Addendum 128– UN Regulation No. 129

Revision 3 – Amendment 2

03 series of amendments – Date of entry into force: 29 December 2018

Uniform provisions concerning the approval of Enhanced Child Restraint Systems used on board of motor vehicles (ECRS)

Figures of Strapped child

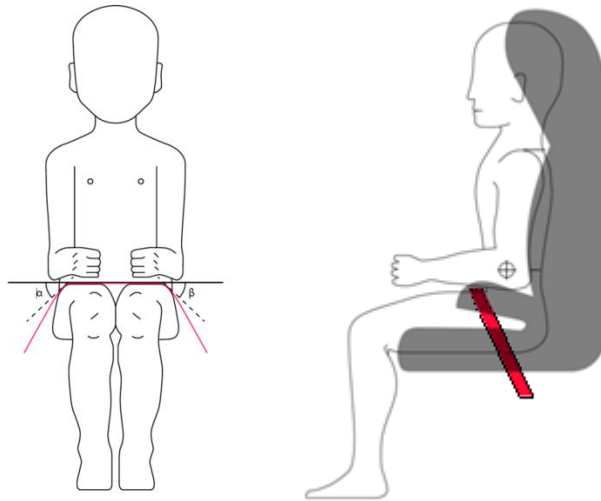
Paragraph 6.2.1.5., amend to read:

- "6.2.1.5. All restraint ... excessive stresses.

In the case of booster seats, the lap portion of the adult safety-belt shall be positively guided on both sides to ensure that the loads transmitted by the adult lap belt are transmitted through the pelvis. The positive guidance of loads over the pelvis shall be realised from the moment that the child is installed; the lap belt shall pass over the top of the thigh, just touching the fold with the pelvis. The angles α and β between the tangent line in which the belt touches the thighs and the horizontal shall be greater than 10°.

The shoulder portion of the adult safety belt shall be positively guided to ensure that the child torso and neck do not escape."

Figure 2
Arrangement for testing a rearward-facing device, not supported by the dashboard

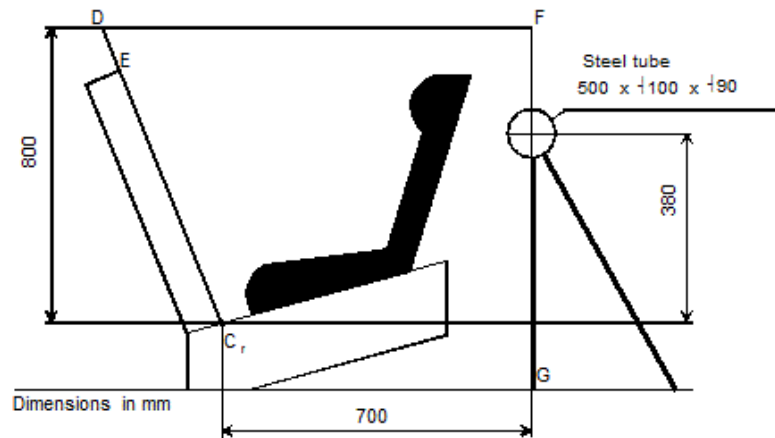
Paragraph 6.6.4.4.1.2.1., amend to read:

"6.6.4.4.1.2.1. Head excursion: no part of the head of the dummy shall pass beyond the planes FD, FG and DE, as shown in figure 2 below. This shall be judged up to 300 ms or the moment that the dummy has come to a definitive standstill whatever occurs first.

Except when testing using Q6 or Q3 dummy where the value in relation to the FD plane is 840 mm.

Where a test is conducted with paragraphs 6.6.4.1.6.1.1. or paragraph 6.6.4.1.6.1.2. or paragraph 6.6.4.1.8.2. above, only the second test results without 100 mm diameter bar will be considered.

Figure 4

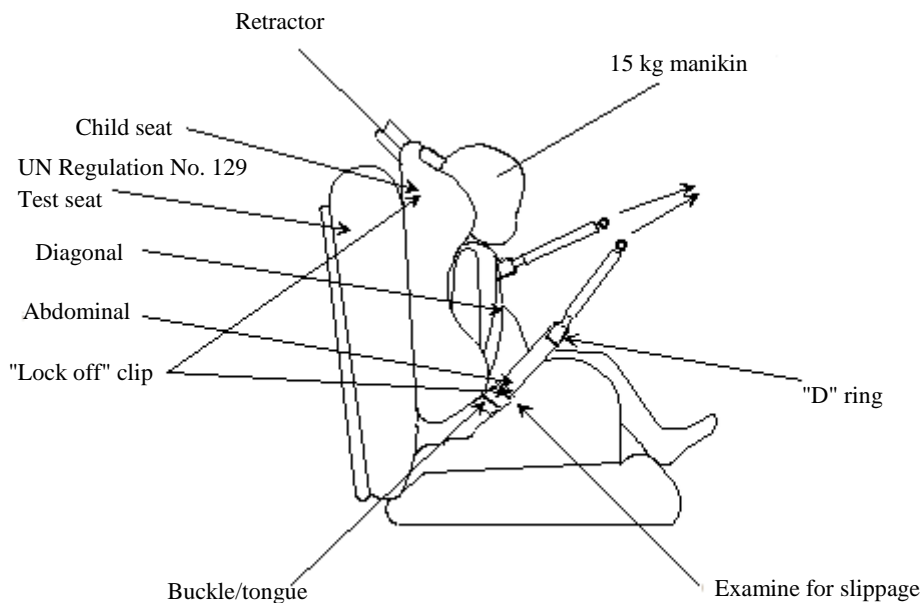
Insert new paragraphs 7.2.9. to 7.2.9.2., to read:

"7.2.9. Lock-off devices

7.2.9.1. Class A devices

The Enhanced Child Restraint System and the largest manikin for which the Enhanced Child Restraint System is intended shall be set up as shown in Figure 4 below. The webbing used shall be as specified in Annex 23 to this Regulation. The lock-off shall be fully applied and a mark made on the belt where the belt enters the lock-off. The force gauges shall be attached to the belt via a D ring, and a force equal to twice (± 5 per cent) the mass of the heaviest dummy for the size range shall be applied for at least one second. The lower position shall be used for lock-offs in position A and the upper position for lock-offs in position B. The force shall be applied for a further nine times. A further mark shall be made on the belt where it enters the lock-off and the distance between the two marks shall be measured. During this test, the retractor shall be unlocked.

"Annex 2

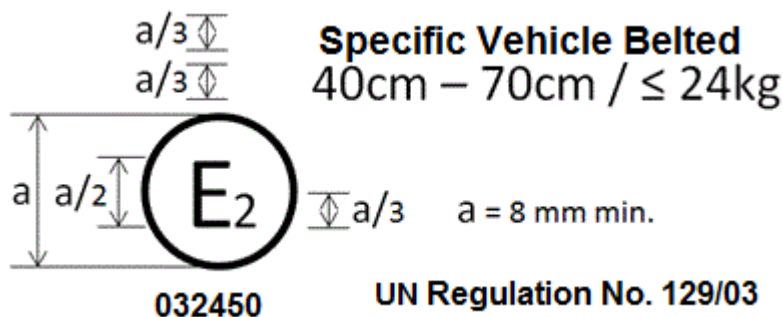
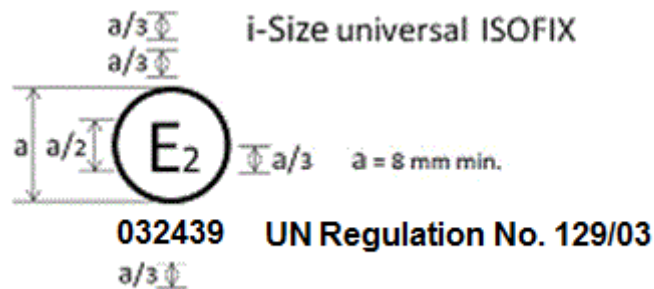
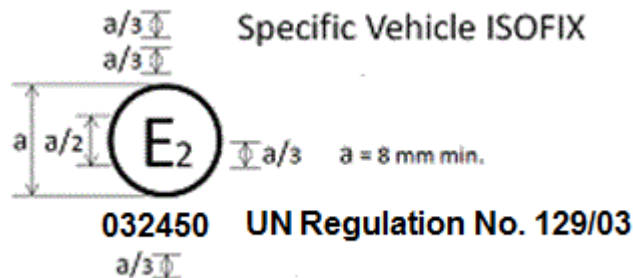
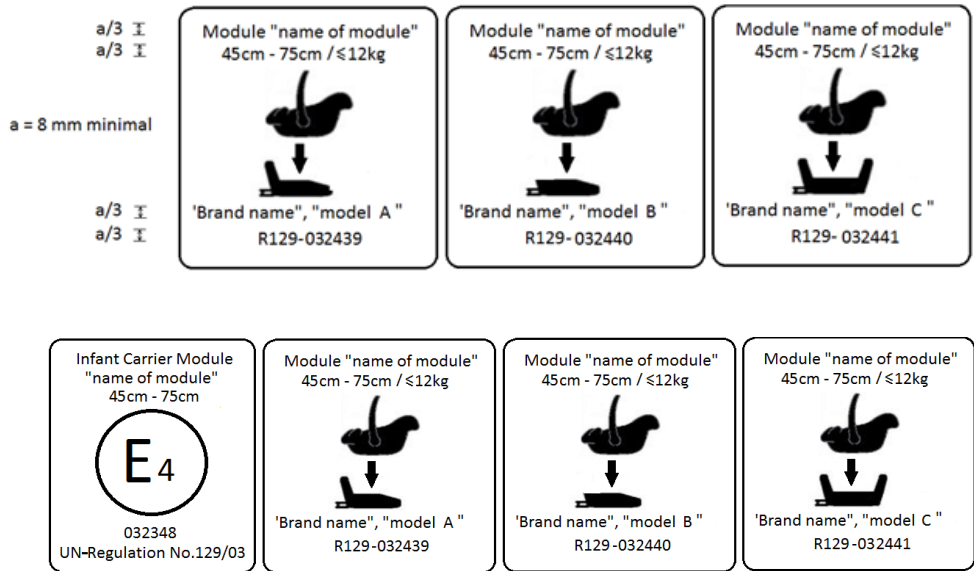
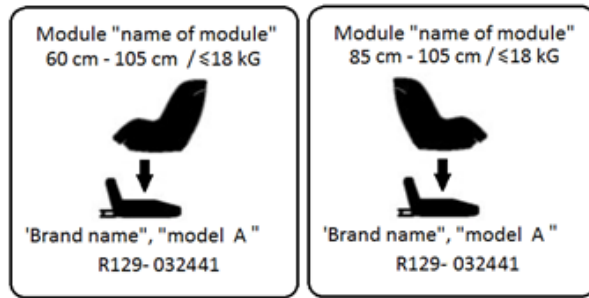
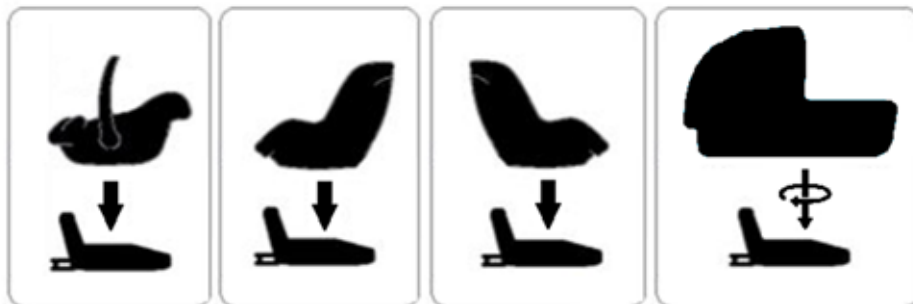
Annex 2, amend to read:

The Enhanced Child Restraint System bearing the above approval mark is a device capable of being fitted in any universal seating position of the vehicle and of being used for the 40 cm - 70 cm size range; it is approved in France (E 2) under the number 032439. The approval number indicates that the approval was granted in accordance with the requirements of the UN Regulation on approval of Universal Belted Enhanced Child Restraint Systems used on-board of motor vehicles as amended by the 03 series of amendments. In addition the name of the UN Regulation must be identified on the approval mark followed by the series of amendment according to which the approval has been granted.

The Enhanced Child Restraint System bearing the above approval mark is a device not capable of being fitted in every vehicle and capable of being used for the 40 cm - 70 cm size range; it is approved in France (E 2) under the number 032450. The approval number

In case the Enhanced Child Restraint System is equipped with a module, the size range and the mass limit are not on the approval mark but on the module mark.

The Enhanced Child Restraint System bearing the above approval mark is a device, including module(s), capable of being fitted in any i-size compatible vehicle seating position. It is approved in France (E 2) under the number 032439. The approval number indicates that the approval was granted in accordance with the requirements of the UN Regulation concerning the approval of Enhanced Child Restraint Systems used on-board of motor vehicles as amended by the 03 series of amendments. In addition the name of the UN Regulation has to be identified on the approval mark followed by the series of amendment according to which the approval has been granted.

The Enhanced Child Restraint System bearing the above approval mark is a device, including module(s), not capable of being fitted in every vehicle. It is approved in France (E 2) under the number 032450. The approval number indicates that the approval was granted in accordance with the requirements of the UN Regulation concerning the approval of Specific vehicle ISOFIX Enhanced Child Restraint Systems used on-board of motor vehicles as amended by the 03 series of amendments. In addition the name of the UN Regulation has to be identified on the approval mark followed by the series of amendment according to which the approval has been granted.

2.1.1. Where a module is approved for use with more than one base, the individual base and module combinations shall be indicated on the module in separate module marks, each bearing their applicable size ranges.

The module bearing the above marks is capable of being used as a Universal Belted Enhanced Child Restraint System for the 45 cm - 75 cm size range; it is approved according to UN Regulation No. 129-03 under the number 032348.

2.1.2. Where a module is capable of being installed in different orientations, separate module marks shall be indicated on the module, each bearing their applicable size ranges.

- 2.2. Examples of the symbols to be used on the module mark are given in the figures below. As chosen by the Enhanced Child Restraint Systems manufacturer, one of the symbols or an equivalent shall be used on the module mark.

Figure 1
Procedure type 1

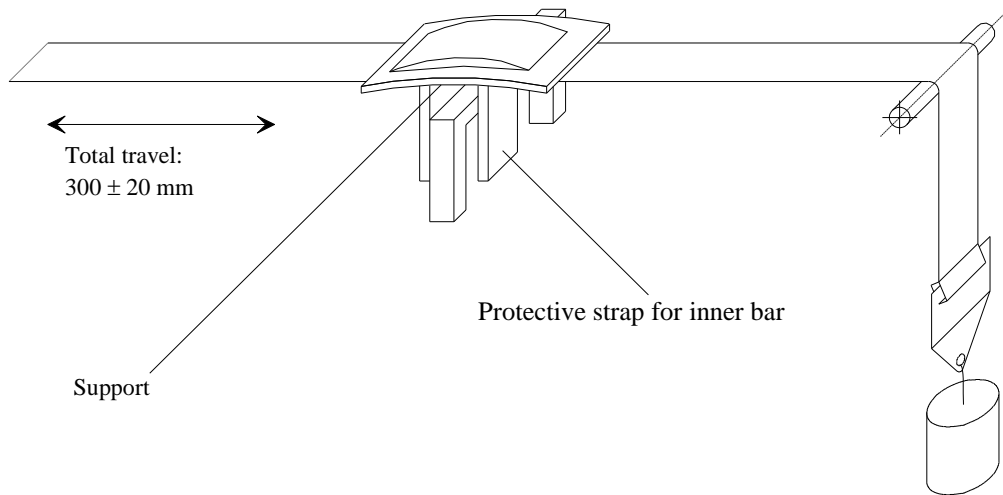
Annex 5, Figures 1 and 2, amend to read:

$F = 10 \pm 0.1 \text{ N}$, can be increased up to maximum $F = 60 \pm 0.5 \text{ N}$ (see table 8, paragraph 7.2.5.2.6.2.)

Figure 2
Procedure type 2
Following two examples of test set up

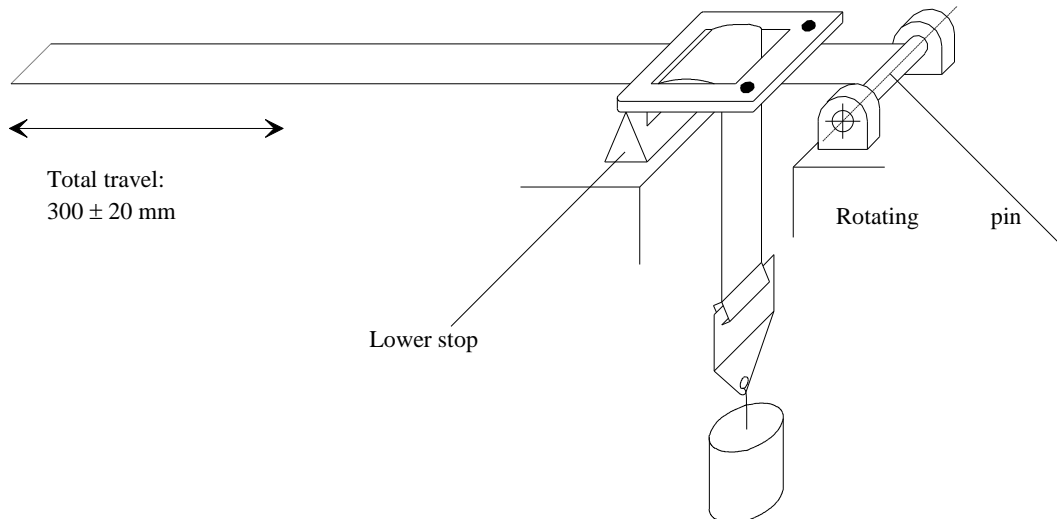
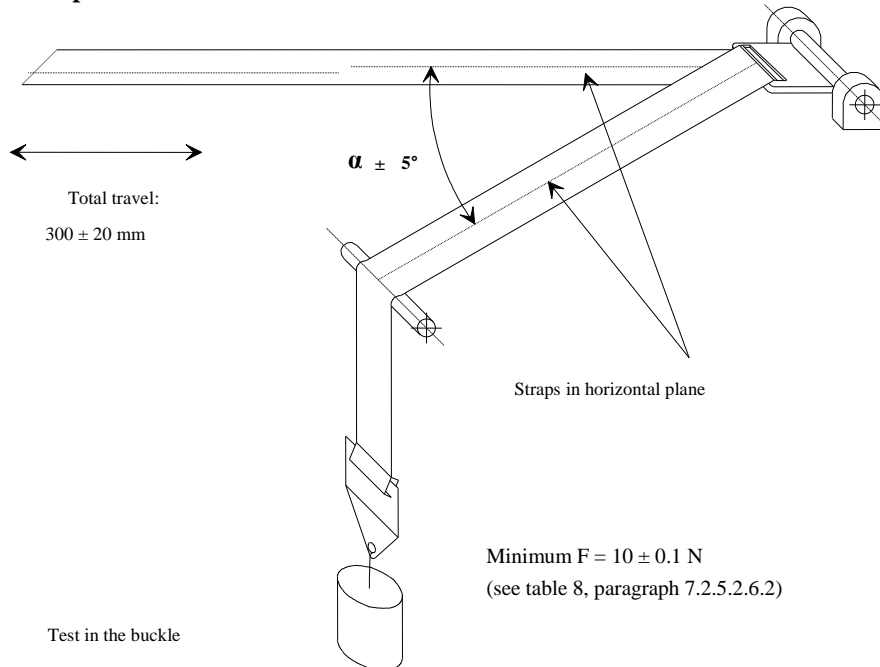
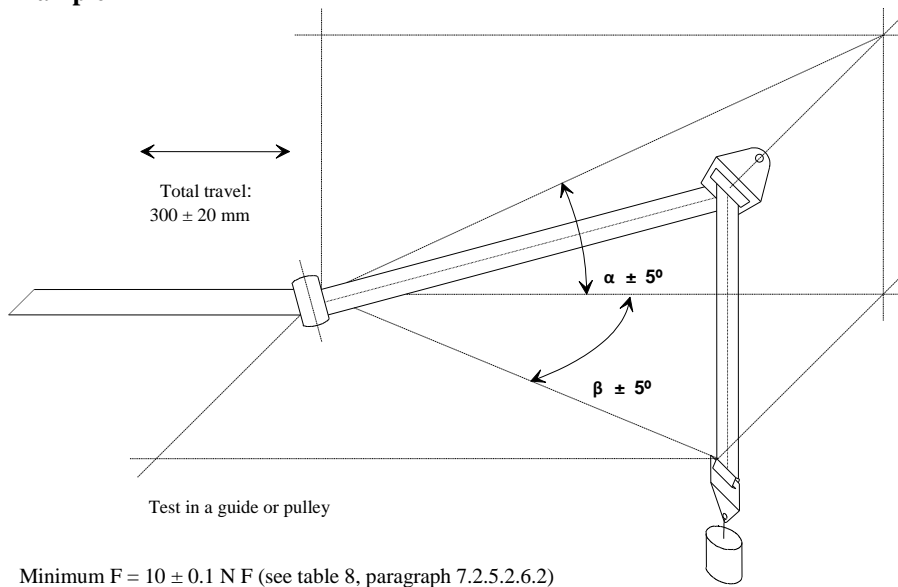
$F = 10 \pm 0.1 \text{ N}$, can be increased up to maximum $F = 60 \pm 0.5 \text{ N}$ (see table 8, paragraph 7.2.5.2.6.2.)

Where α and β reproduce the angles as in the real installation (in three dimensions)
..."

"Figure 5

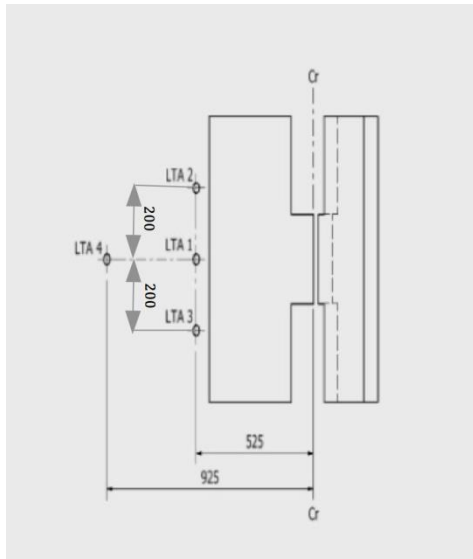
Appendix 2, insert new figure 5:

Lower strap anchorages (LSA 1, LSA 2, LSA 3 and LSA 4)

Figure 3

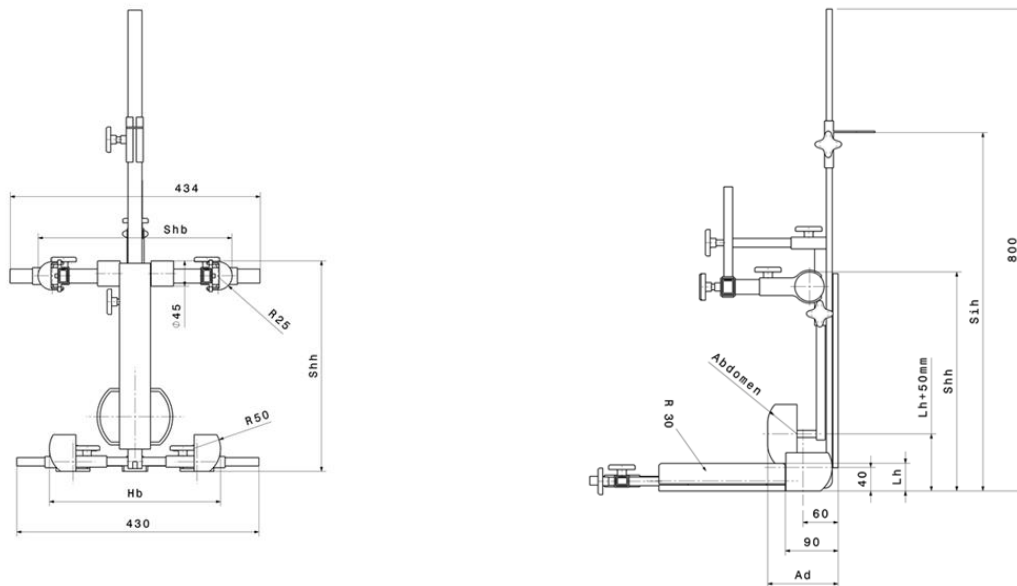
Annex 18, amend to read:

Side and Front View of the measuring device for measurements applicable to Enhanced Child Restraint Systems that feature an impact shield
